UNITED STATES PATENT AND TRADEMARK OFFICE

Office Action Summary

10/083,764

LICCIARDI, PIA C.

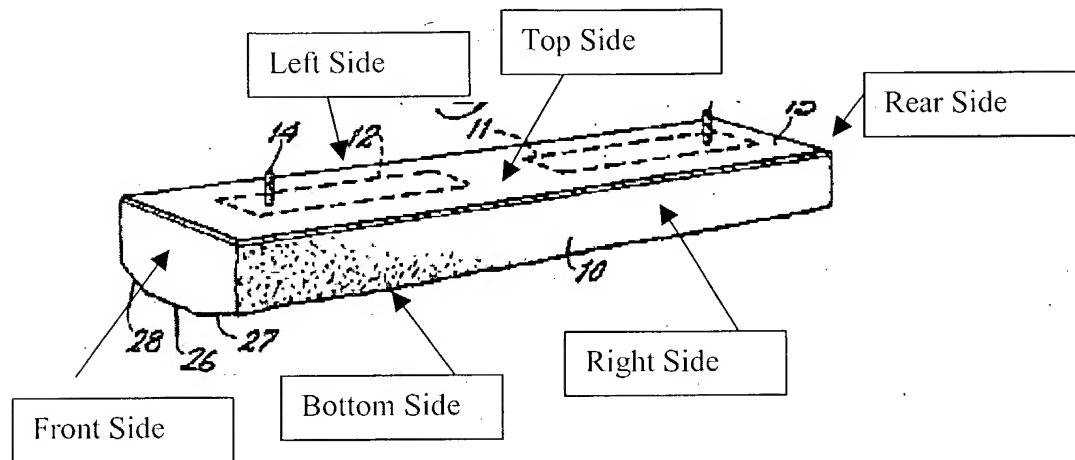
Claims 1-5, 11-14, 17-19 are rejected under 35 U.S.C. 102(b) as being anticipated by Rebernak (USPN 3038188).

Rebernak teaches a mop head comprising a top surface, a bottom surface and two side surfaces (see figure below). The top surface adjoins the right and left side surfaces at an edge. The edge extends from the front surface to the rear surface. The side surfaces have a sculpted cutout (27, 28, figure 2) that will correspond to the shape of quarter round molding when placed in contact. A support member (16) is attached to the top surface of the mop head and a handle

(20) is attached to the support member. The side surfaces of the mop head extend beyond the side surfaces of the support member (figure 1).

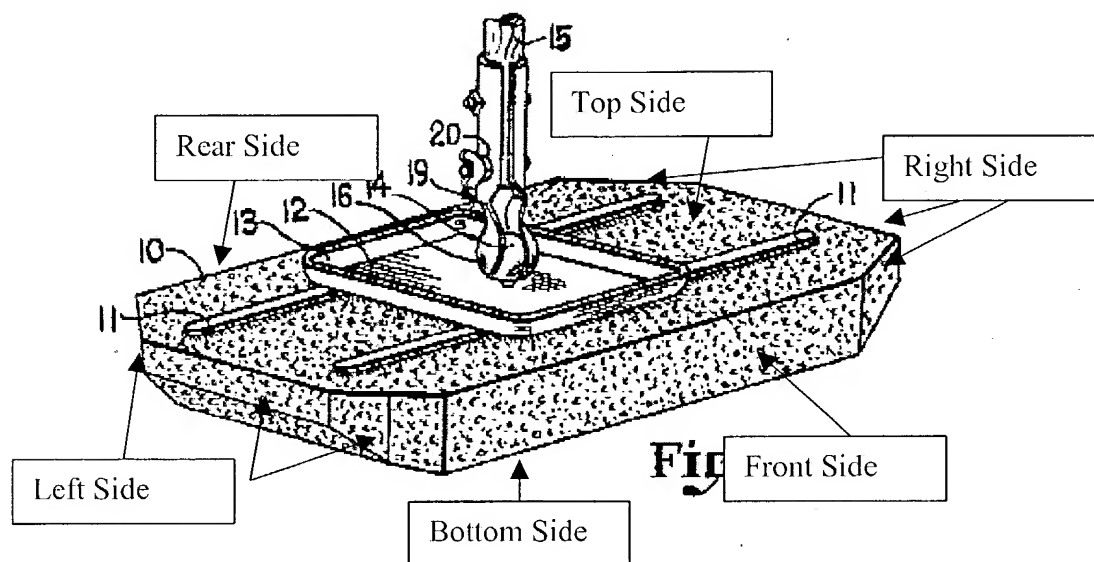
Claims 1-5, 11-14, 17-19 are rejected under 35 U.S.C. 102(b) as being anticipated by Wheeler (USPN 3214779).

Wheeler teaches an octagonal mop head comprising a top surface, a bottom surface and two side surfaces (see figure below). The top surface adjoins the right and left side surfaces at an edge. The edge extends from the front surface to the rear surface. The side surfaces have a sculpted cutout (col. 2, lines 18-21 and figures 1 and 2) that will correspond to the shape of a quarter round molding when placed in contact. A support member (12) is attached to the top surface of the mop head and a handle (15) is attached to the support member. The side surfaces of the mop head extend beyond the side surfaces of the support member (figure 1).
